Product Change Notification (PCN)

PCN Number	501794	Date Issued	March 31, 2017
Reason for Change	Change to Product		
Change Type Description	This letter is to inform you that changes are being made to the part(s) identified in this Notice. The change will affect the fit, form, function or appearance of the parts. Or, it may result in a change to the specification. The pictures below show an example of the possible differences.		
Reason for Short Notice	Special Request		
Assessment of Change	Test report/Specification Test Report		
Internal Molex Qualification Date	November 15, 2016		
Sample Availability Date (Changed Part)	November 15, 2016		
Planned Implementation Date	April 30, 2017		
Method of Identifying Change	Lot information on label

Add Gold Plating at First Mating Area

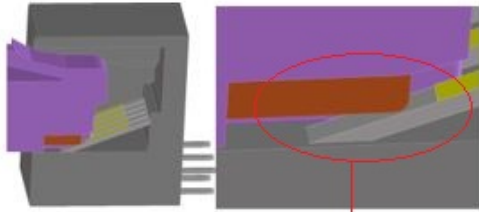
Before Change

First Mating Area will be changed.

After Change

- Add gold plating at first mating area, optimize contact wiping process.
- Product Impact
 - No impact to fit
 - Impact to appearance of terminal
- Part Number Impact
 - see attached impacted parts list
- PPAP and samples available upon request
